BEFORE THE HEARING COMMISSIONERS

of a subdivision to create 242 residential lots within the C2 Growth Cell, and associated lots for public assets by 3MS of Cambridge GP Limited (SP/0179/20)

STATEMENT OF EVIDENCE OF JIMMY JIENAN ZHUANG (Urban Design)

Dated: 18 May 2021

UD0201 A

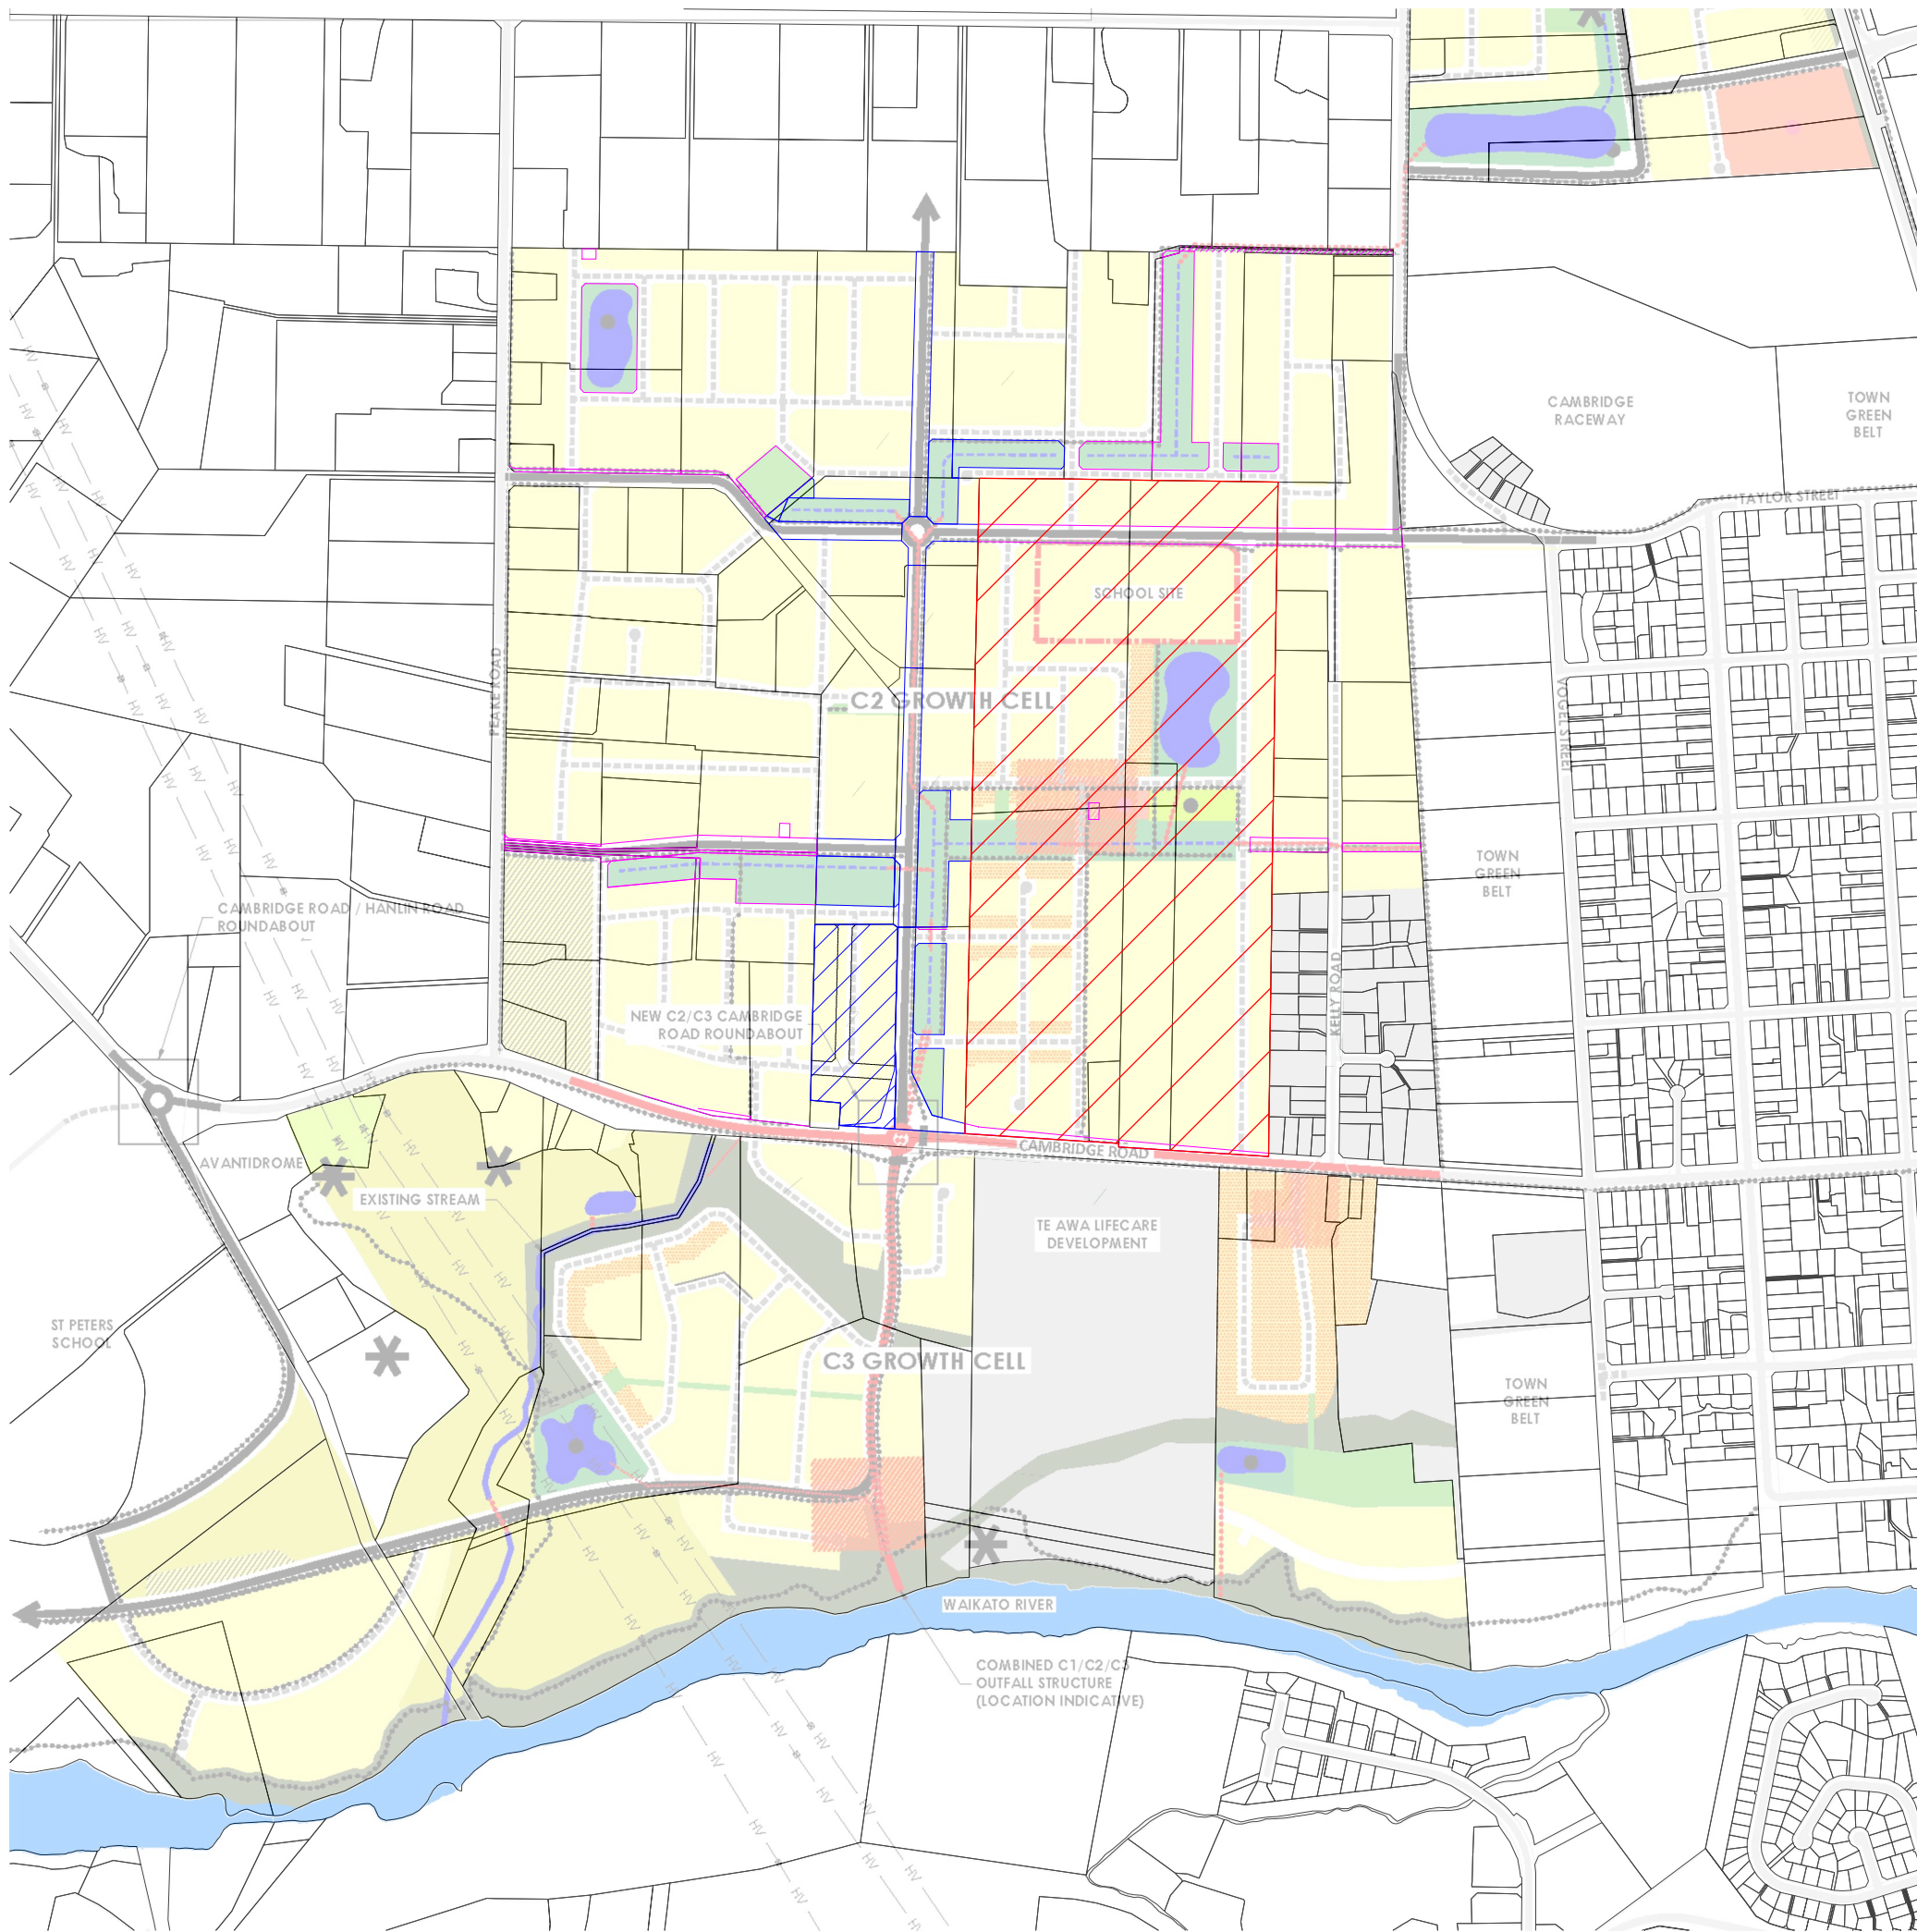
- 6.4. Comparing to the Notified Version, the Refined Version does present a much reduced effect on the Submitter 4's Land (refer to **Table 1** for a quantitative comparison and summary).
- 6.5. The urban design related effects of the departures (of the Notified Version) from the Structure Plan, on Submitter 4's land include:
- a. reduction in land for future residential development/allotments (refer to **Table 1** for quantitative comparisons)
 - i. land removed from Submitter 4's land for the Collector Road and its associated roundabout with Cambridge Road

(Drawings – UD0201 to UD0202).

UD0202

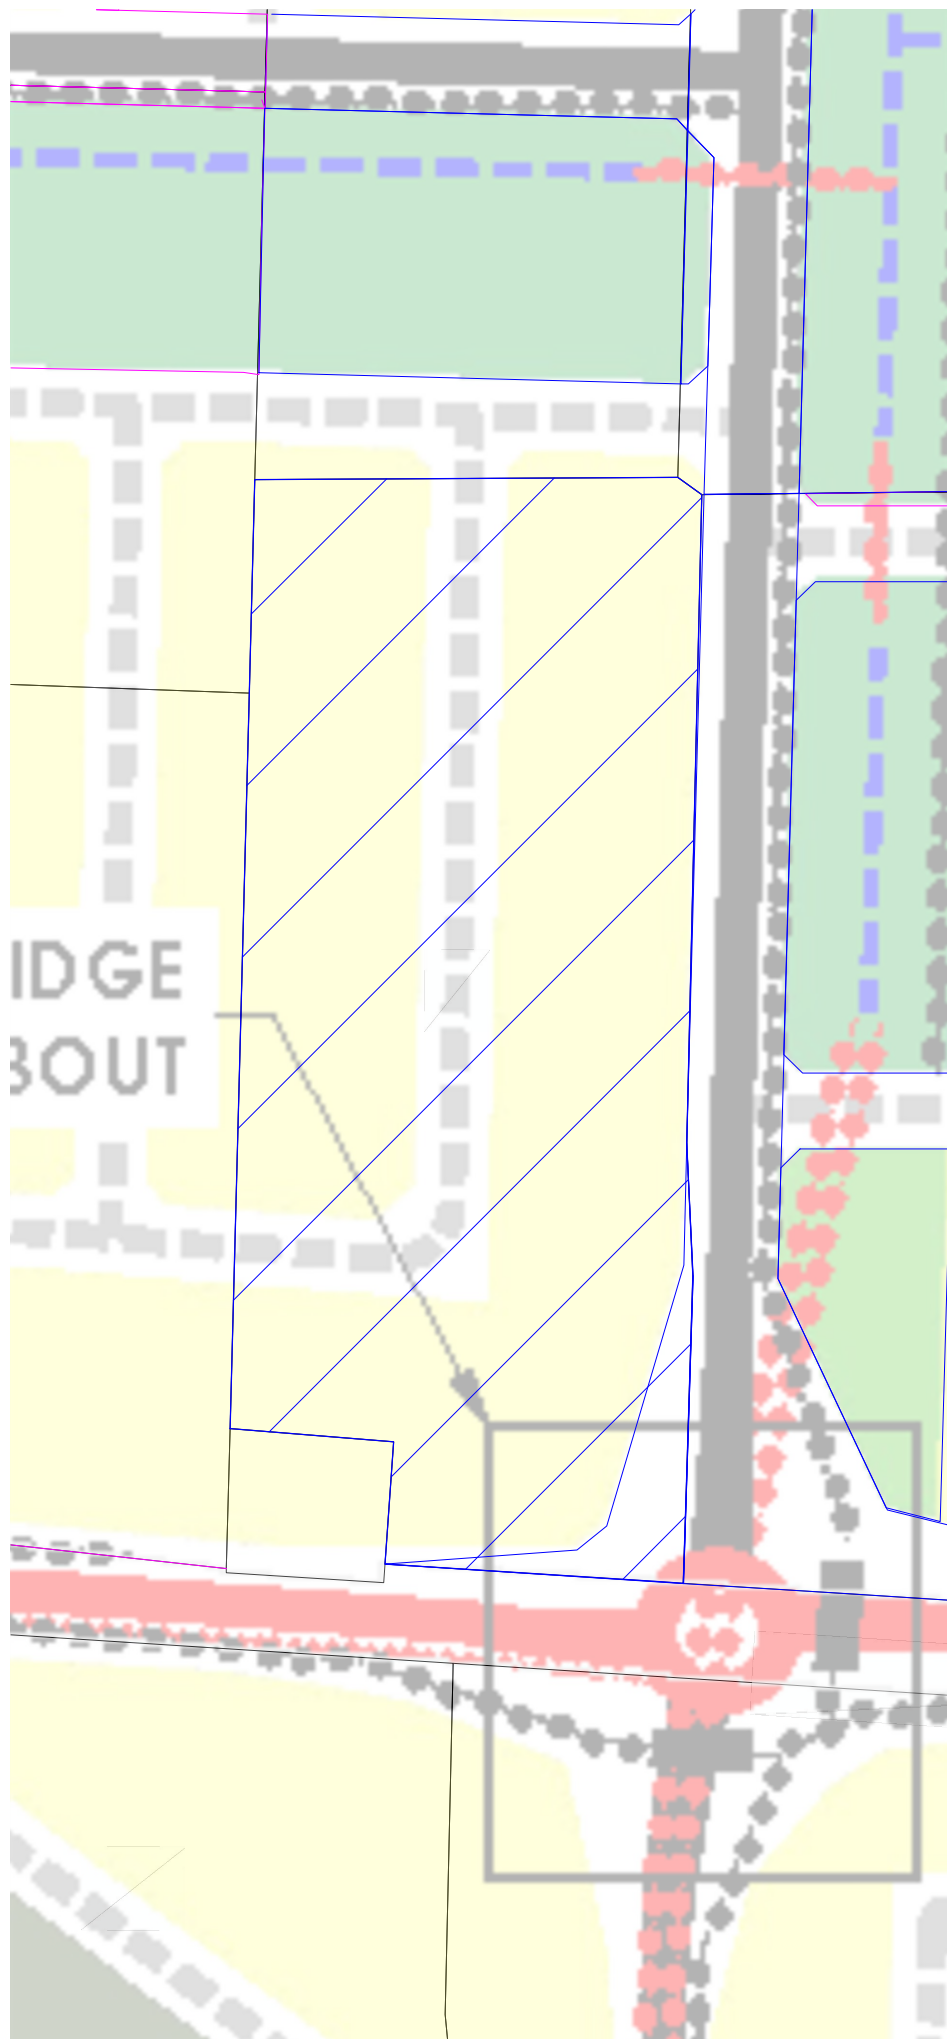
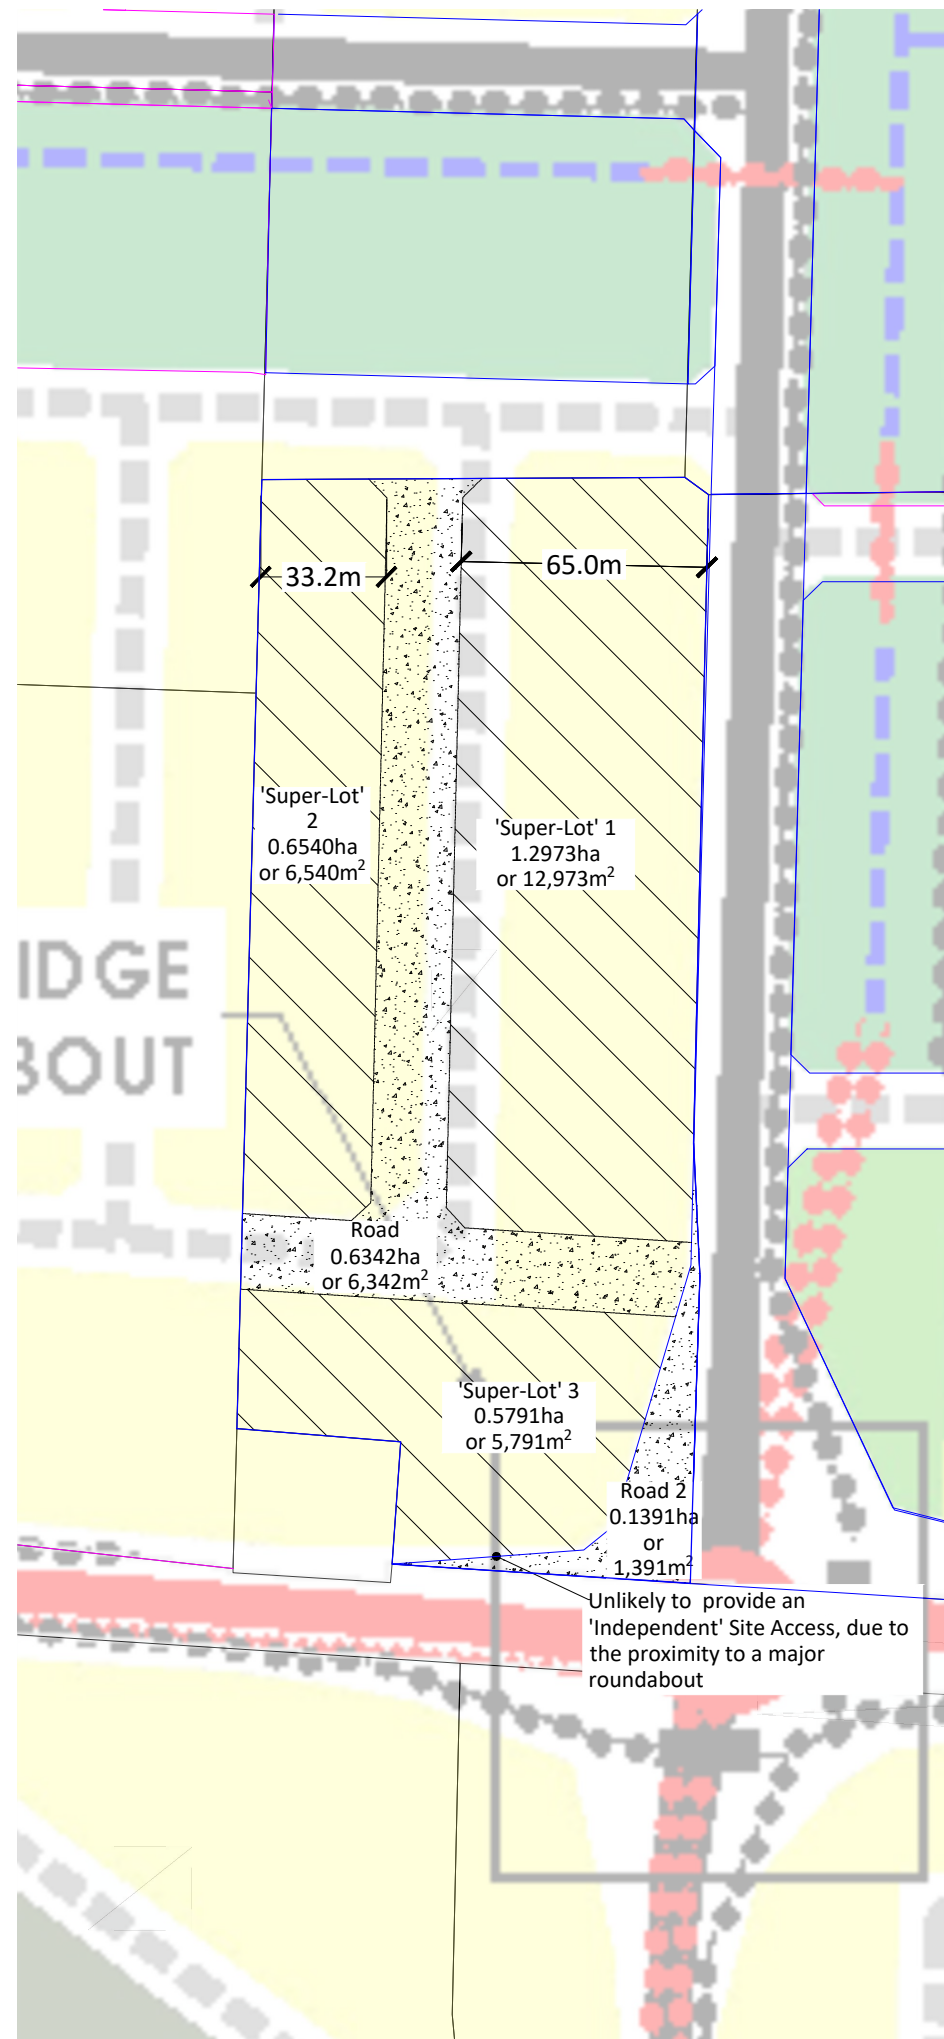
6.6. Responding to the changes in the Refined Version, I design a hypothetical and potential site/street-block layout of the Submitter 4's land, which can be similar to what I show in the Structure Plan context, with some rationalisation (**Drawings – UD0202**). Similar design and development outcomes can be achieved for Submitter 4's land as per in the Structure Plan. I have discussed about this in paragraphs **5.14 to 5.17** of this statement.
